Staff Report

Natural Resources Impact Review

NR-03-23

December 19, 2023

**BRANDIS MEADOWS TOWNHOME SUBDIVISION
 NATIVE RESOURCE BUFFER REDUCTION PLAN**

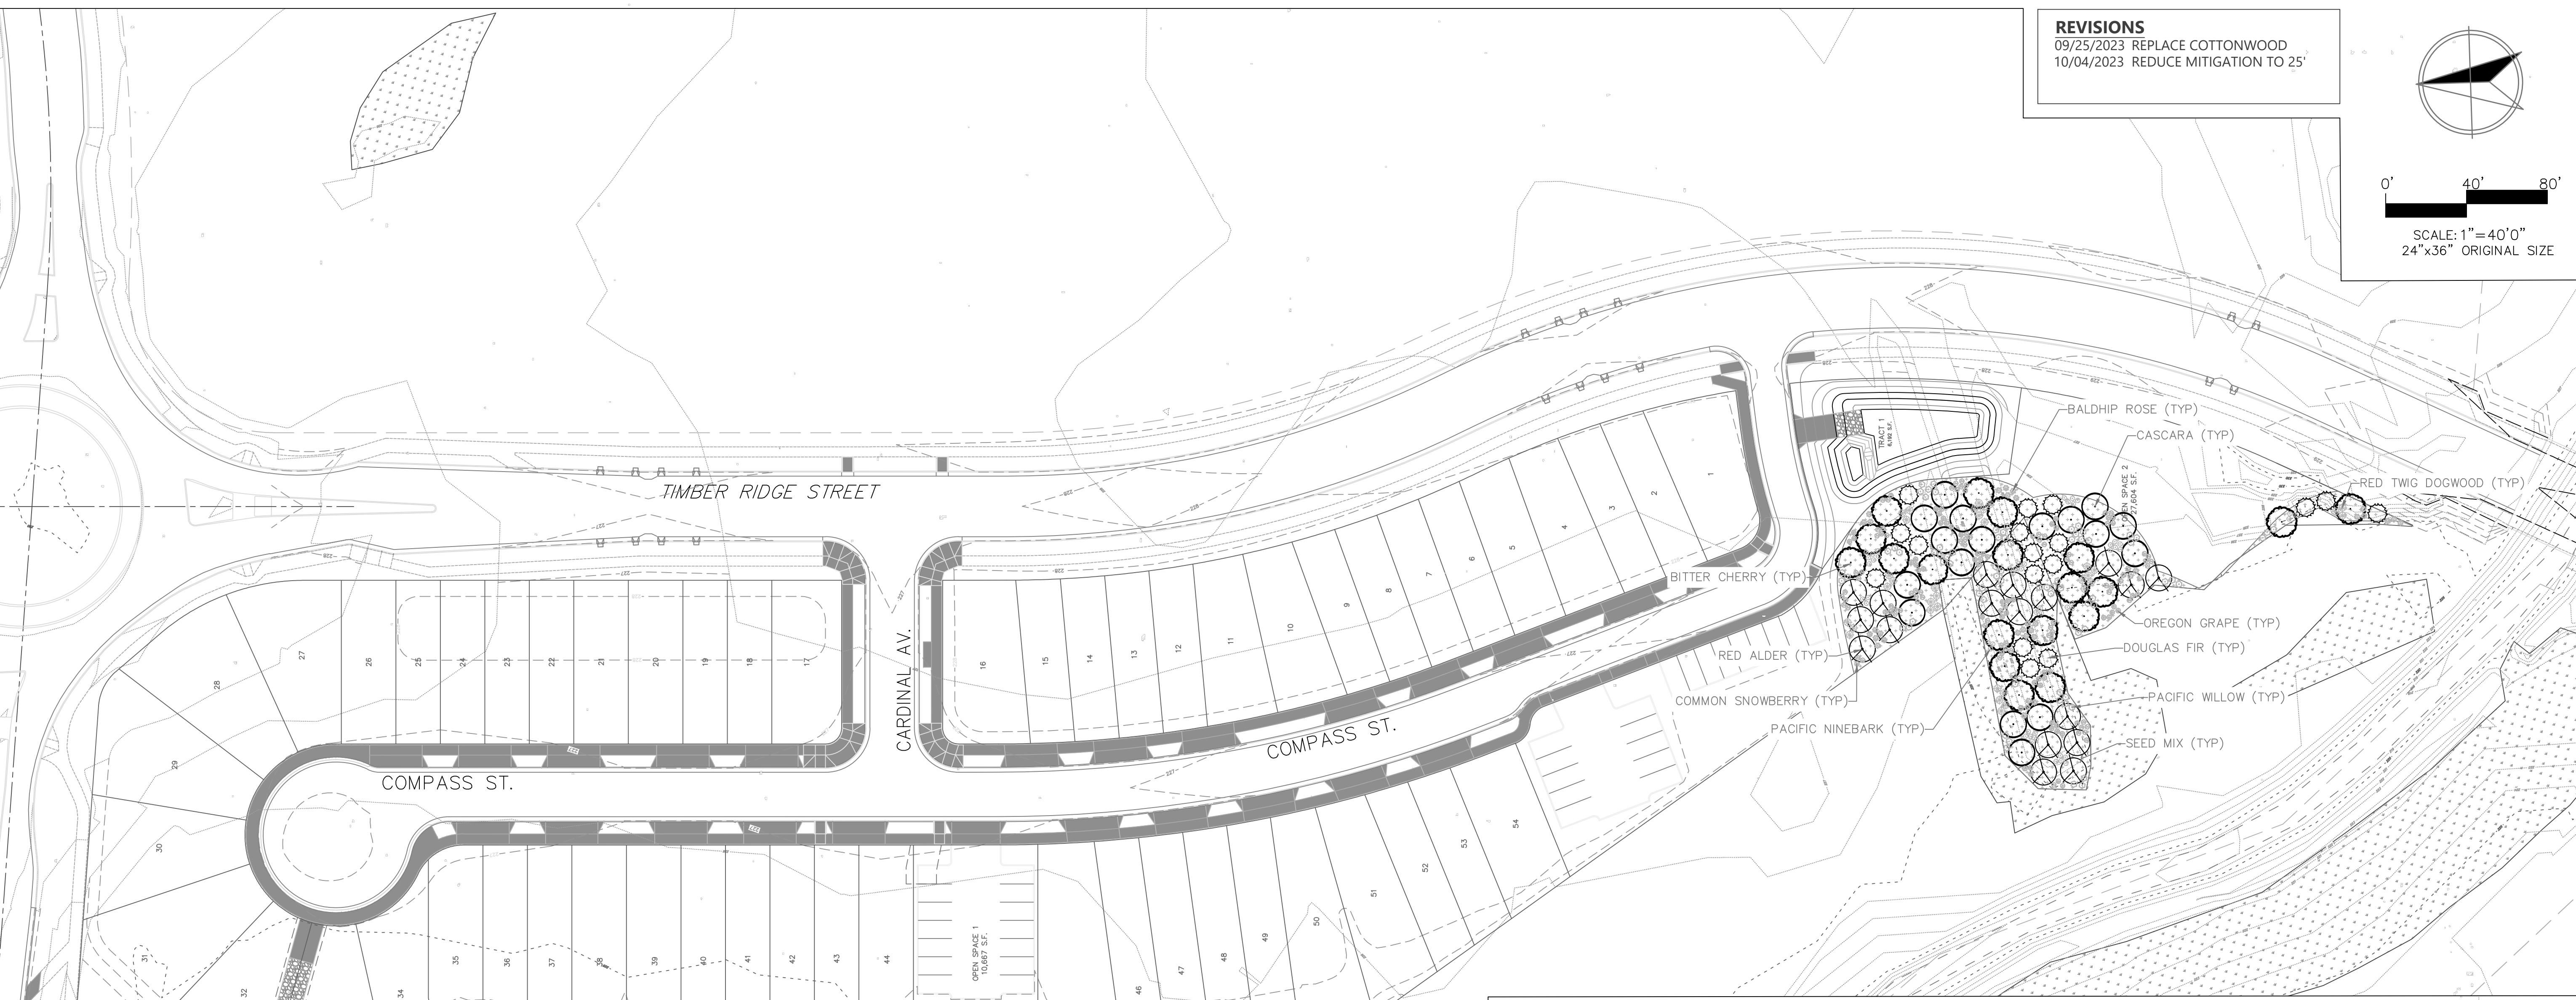
- 3.5 The applicant's landscape architect, Andrew Leisinger, determined that the existing resource quality is "Marginal," as it is described in Table 6.410-1 of the ADC. The plan being submitted indicates that the mitigation strategy will restore the riparian buffer area to "Good Quality," (Attachment G.1). He notes that the only native species on site are cottonwood trees. The only nonnative species on site is Himalayan blackberry. His report provides a recommendation of how to remove the invasive blackberries from the site.

- ii.1 According to the landscape architect, the mitigation plan will consist of installing the following plant materials as indicated on the Native Resource Buffer Reduction Plan (see Attachment H). By installing these plants in their proposed quantities, the natural resource area should improve to a good quality riparian corridor area after successful completion of the Mitigation Plan. All of the selected plant species are native to western Oregon.

**BRANDIS MEADOWS TOWNHOME SUBDIVISION
 NATIVE RESOURCE BUFFER REDUCTION PLAN**

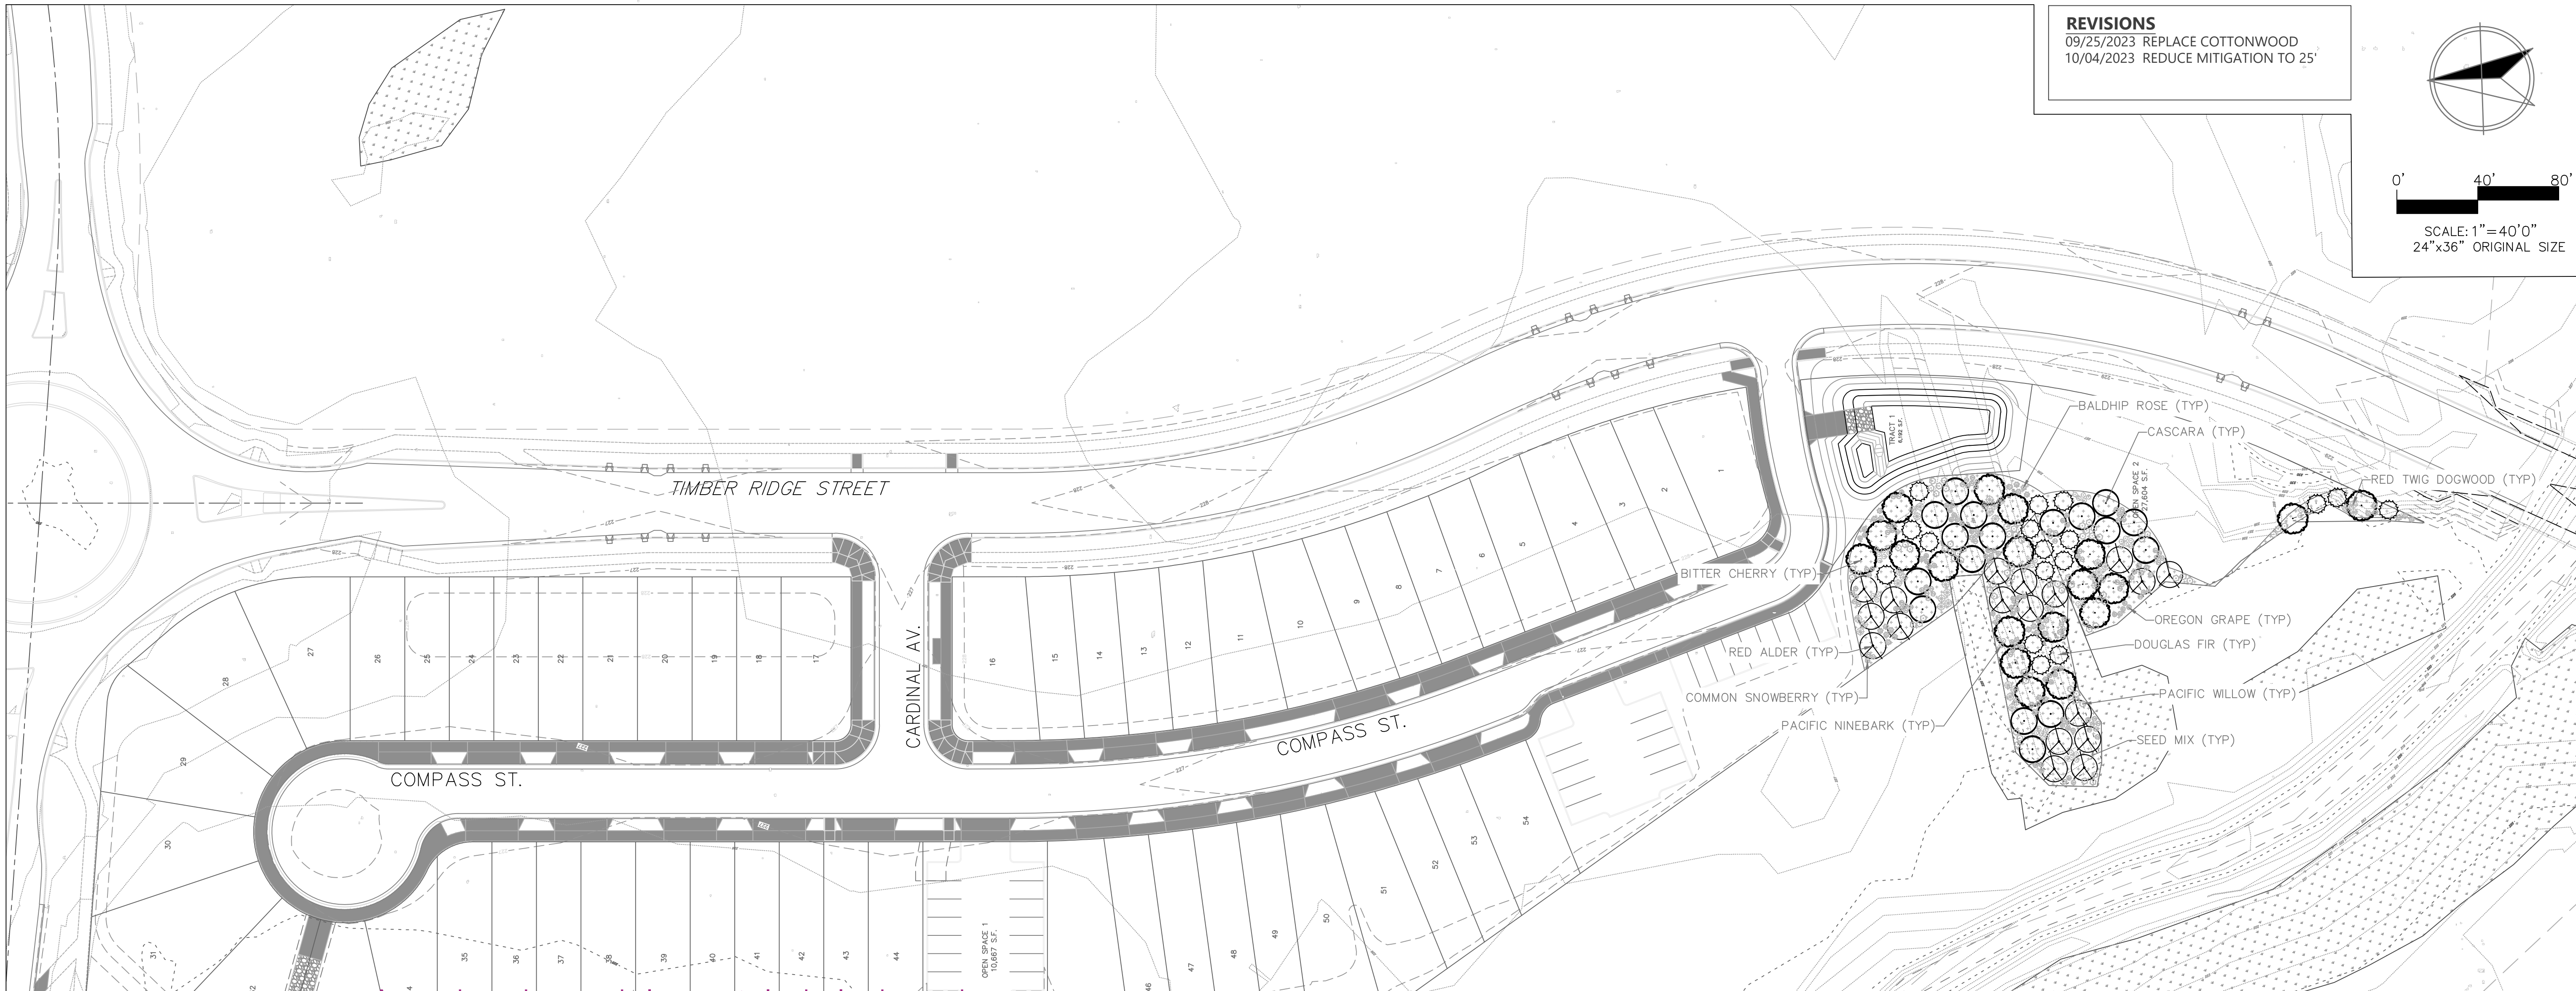
1. The mitigation plan must be revised to widen the Riparian Corridor buffer to the edge of the proposed retaining wall, lot lines and parking areas so that there are no pockets of area within the overlay that are untreated (see Attachment I).

Areas shown in green below must also be landscaped

- Condition 1 The mitigation plan must be revised to widen the Riparian Corridor buffer to the edge of the proposed retaining wall, lot lines and parking areas so that there are no pockets of area within the overlay that are untreated.
